SB20100050 - NEW DAILY

New oil sump for engines 2,3L (F1A)

OVERSIZE OIL SUMP (Ref. 72617)

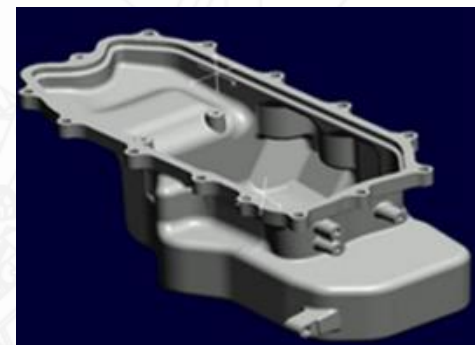
MODEL	A/C	KIT	COMMENT
DAILY 2,3 F1A (STANDARD)	Without A/C	KC05100040	The standard oil sump has a capacity of 5,4 liters
	With A/C	KC15070400	
DAILY 2,3 F1A (WITH OPTION 72617)	Without A/C	KC05100040	The NEW OIL SUMP* has a capacity of 7,5 liters with this option (Réf. 72617). Available only with the models with engine 2,3 liters (F1A).
	With A/C	KC18070465
